Proj. No.: H0562C
File Loc.: Westminster

**RE: REVIEW OF OLIN SECOND QUARTER 2006 GROUNDWATER
MONITORING REPORT**

On behalf of the City of Morgan Hill (City), WorleyParsons Komex has reviewed the report by Olin Corporation (Olin) titled "Second Quarter 2006 Groundwater Monitoring Report, Olin/Standard Fusee Site, 425 Tennant Avenue, Morgan Hill, California" (the Report). Our review focused on the components of the report related to the northeast flow situation wherein perchlorate from the Olin/Standard Fusee site (the Site) has impacted the municipal water supply of the City of Morgan Hill (the City). Our review does not reference the various other potential perchlorate sources which at this time have not been shown to either exist, nor to impact groundwater (in particular the Deep Aquifer), nor to impact any well operated by the City. In particular we reviewed in detail Appendix E, Northeast Groundwater Flow Assessment – Update (Appendix E). The main findings of our review are discussed below. For reader convenience, cited figures from the Report are enclosed with this document.

Groundwater Elevations - Deep Zone (Middle)

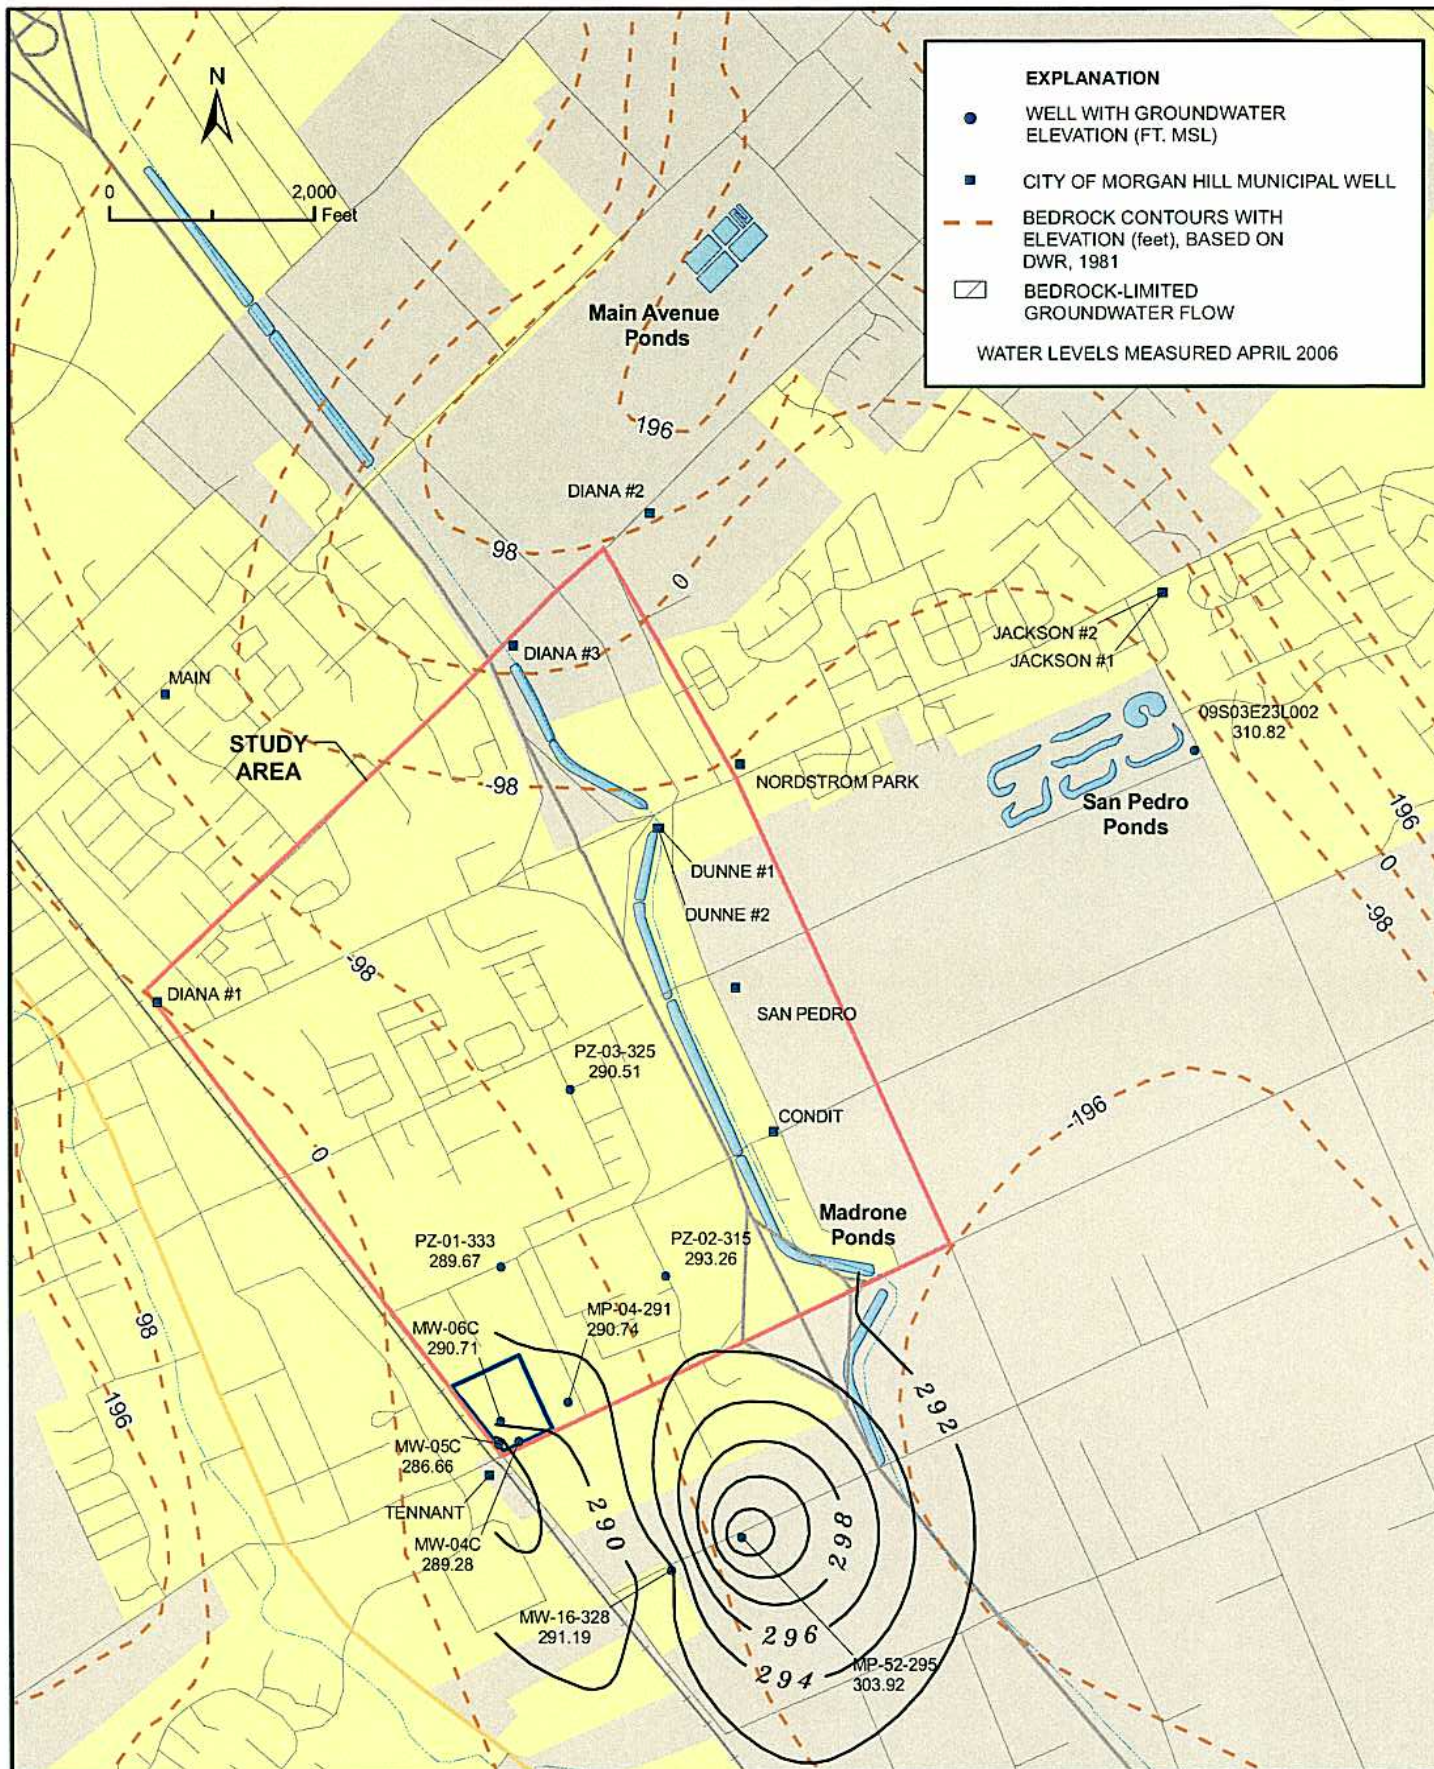
- 2) The water level data contained in the Report illustrates a clear, consistent and irrefutable gradient in several Deep Aquifer zones to the north and even directly to the northeast in the Site vicinity. This is best reflected in Olin's Figures (Figure E5B, E5C and E13 from the Report [enclosed as Attachment A]). In Figures E5B and E5C, a gradient directly to the north and northeast from the Site is clearly shown in Olin's own interpretations, while the continuity of a northward gradient is reflected in Figure E13.

- 3) The text in the Report attempts to minimize the fact that there are north and northeastward gradients and makes statements directly in contradiction to the interpretation of water level elevations and resultant groundwater flow directions indicated in the figures cited in Comment #2 above. Although groundwater flow beneath, and in the immediate Site-vicinity in the Deep Aquifer is shown to be to the north and northeast as noted in Comment #2, the text of the Report in incorrectly states:

Groundwater Elevations - Deep Zone (Lower)
 Second Quarter 2006 Groundwater Monitoring Report
 Olin/Standard Fusee Site
 Morgan Hill, California

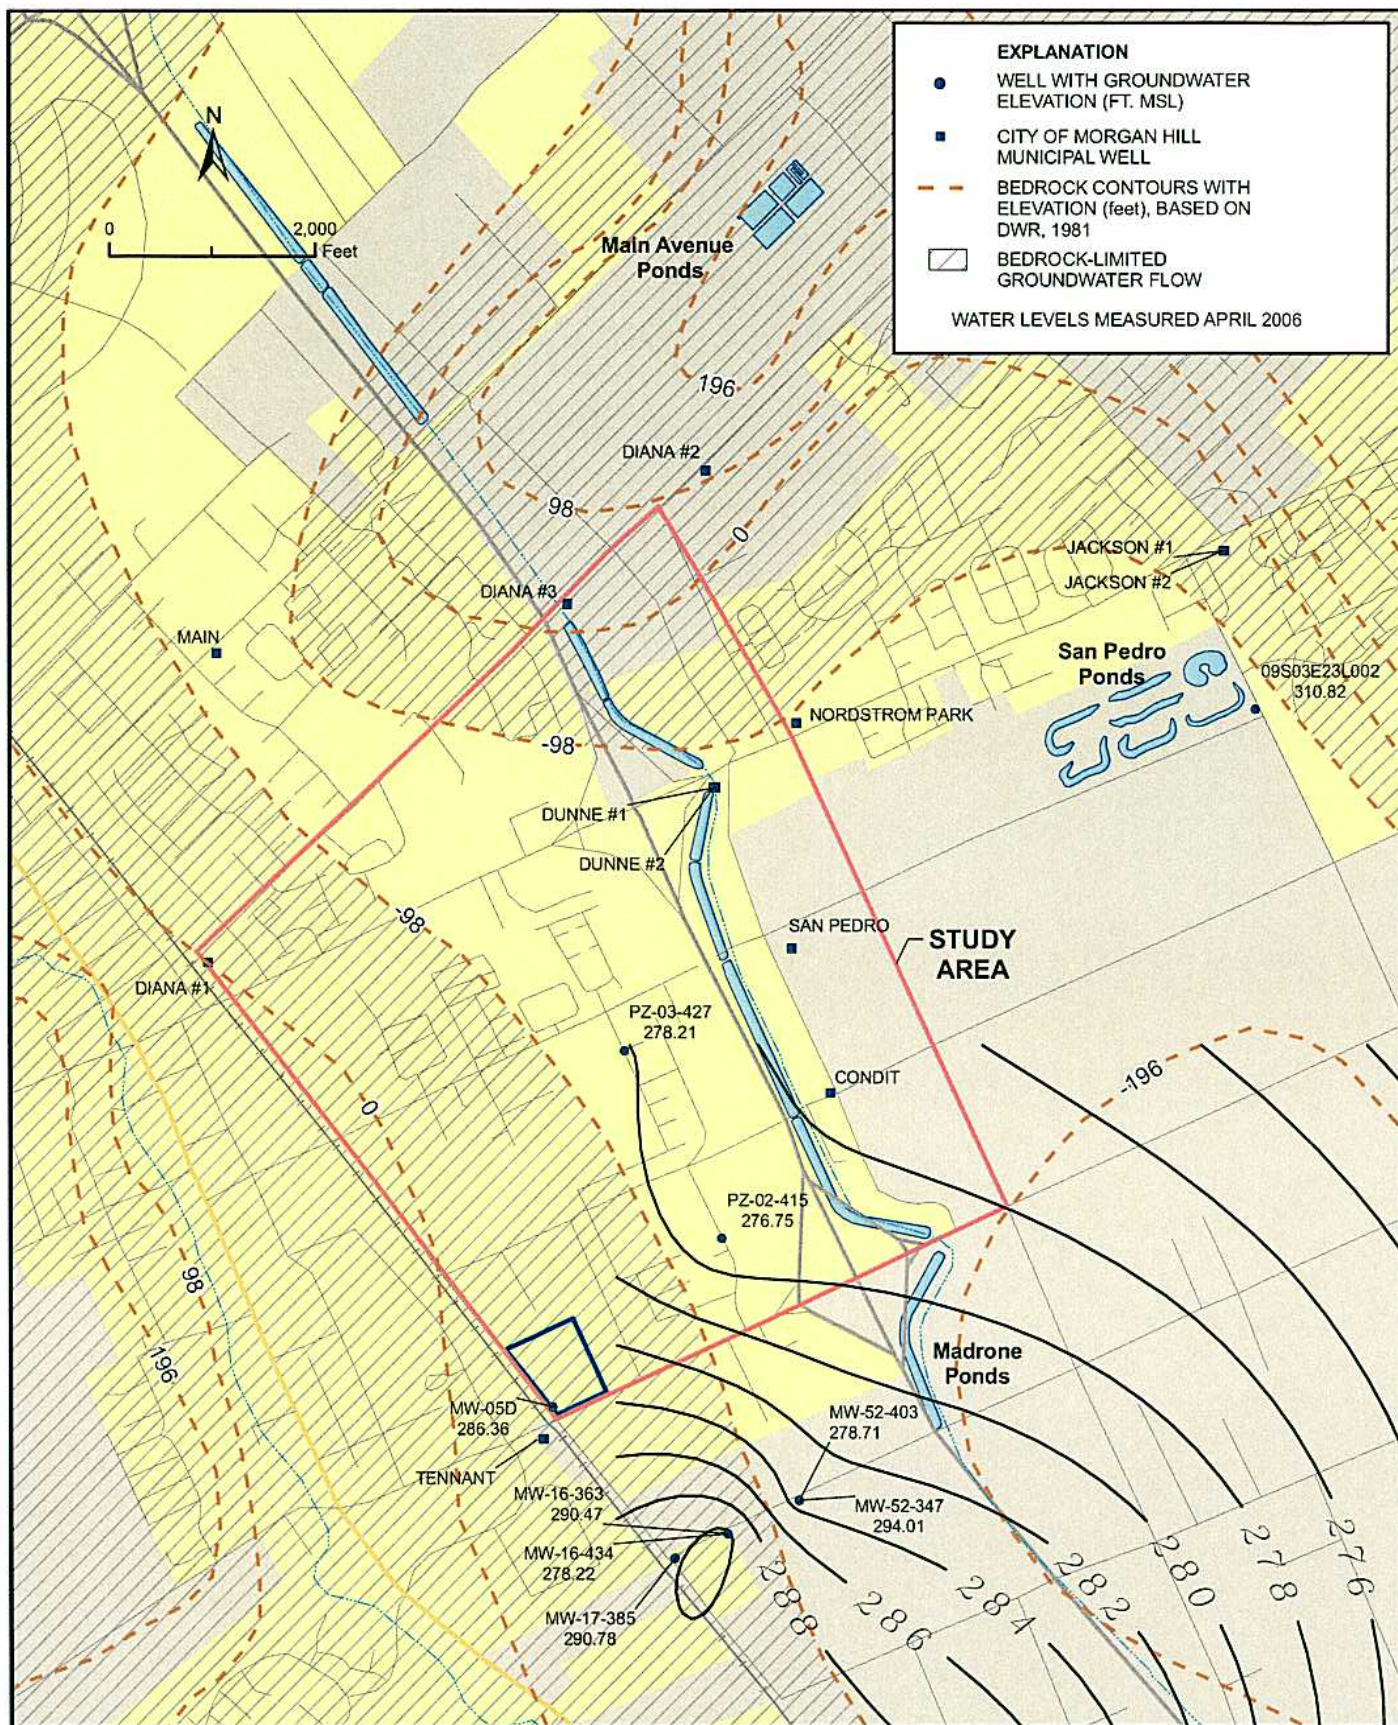
" Incorporation of data from wells located south of the Site along Fisher Avenue, allow for groundwater elevations to be contoured in the lower deep aquifer interval (Figure E5c). April

2006 data generally indicate an overall southward gradient; however, lower elevations measured at PZ-02 and PZ-03 indicate continued downward migration, presumably indicating flow toward deeper portions of the Subbasin”.
